VERMONT YANKEE NUCLEAR POWER CORPORATION

Subject: Request for Exemption - 10CFR Part 50, Appendix R, Fire Protection Program for Nuclear Power Facilities Operating Prior to January 1, 1979

VERMONT YANKEE EXEMPTION REQUESTS FROM
10CFR50, APPEN' IX R

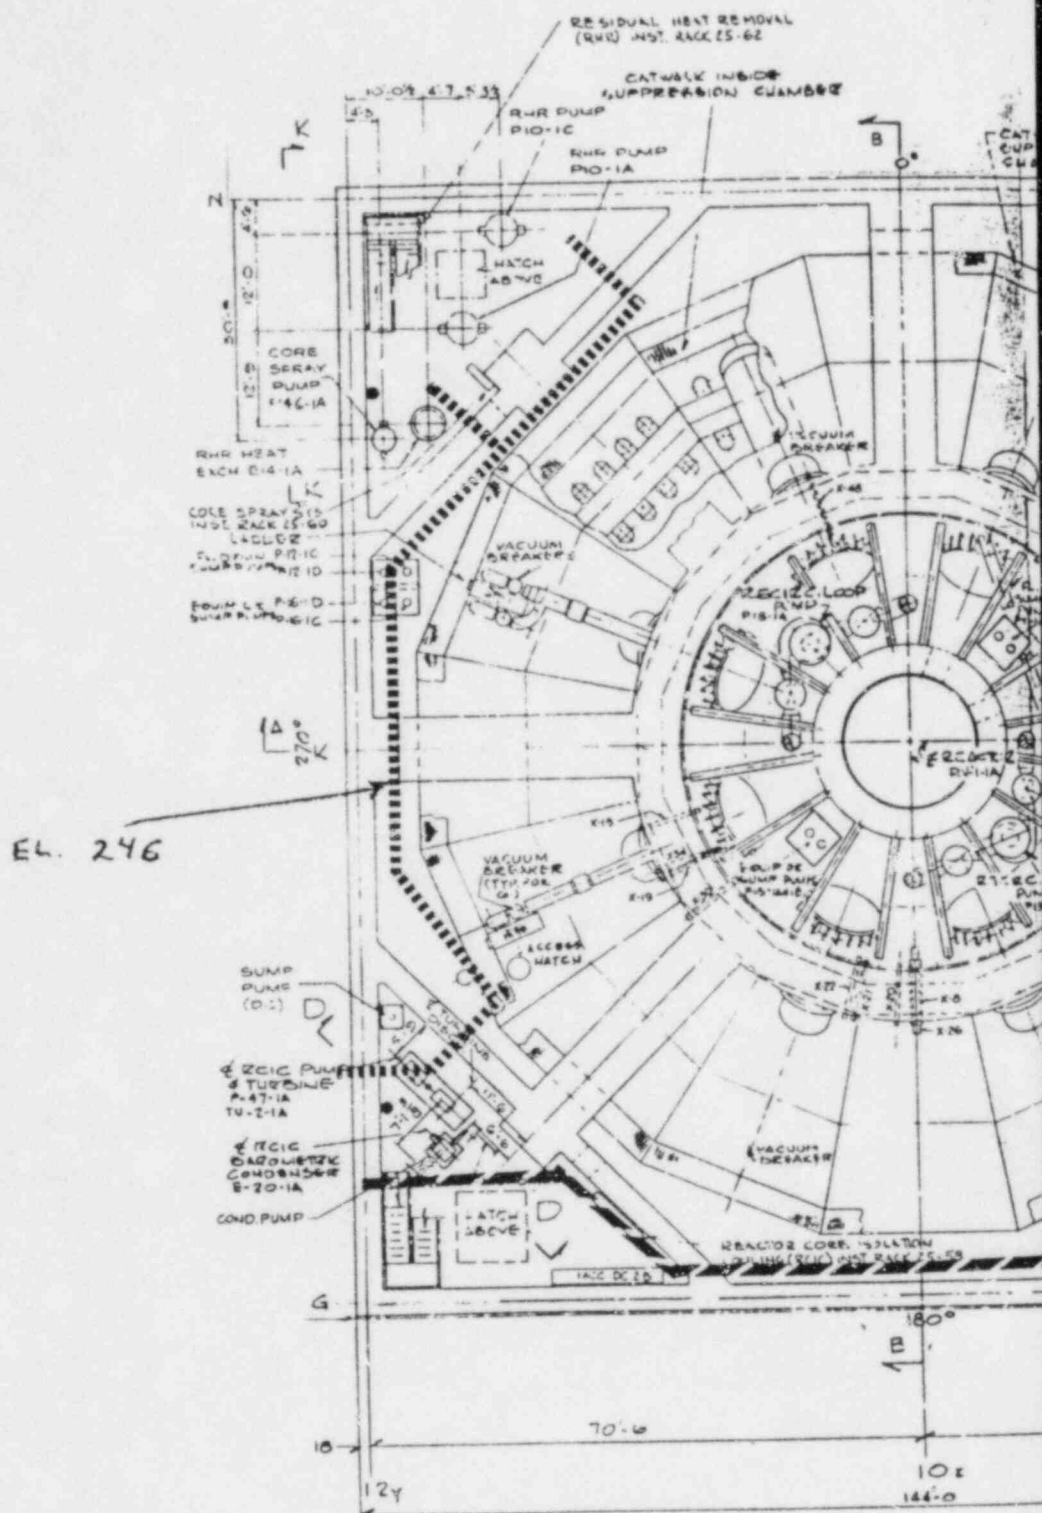
Redundant power and control cables for the Core Spray, RHR, and RHR service water pumps enter the torus area in the northwest corner. These pumps are not needed for hot shutdown. The cables are separated by approximately 30 feet. They then run in a cable tray in opposite directions around the perimeter of the torus approximately 30 feet off the floor until they reach the northeast and southeast corner rooms, where they either enter the corner rooms or a splice box mounted in the torus wall. This configuration is shown on Sketch SK-FP-1 (Attachment A). Up to this point, they are no closer than the 30 feet where they entered the torus.

Each RHR corner room contains two RHR pumps. Within each corner room, one RHR pump is powered from one power system (SI), and one is powered from another power system (SII). To provide the power to these pumps, a set of cables for one RHR pump from each safety train continues in conduit from the splice boxes at each corner room along the east wall of the torus and into the opposite corner room (See drawing SK-FP-1, Attachment A). These cables run beside each other and are redundant to each other. A fire near these conduits could remove power from one RHR pump in each train. However, because each safety train has two redundant RHR pumps (one in one corner room, one in the other corner room), one pump would be left in each train. A fire outside either corner room could remove power from three RHR pumps, two from one train and one in the other train. However, the second pump in one train would be left to operate.
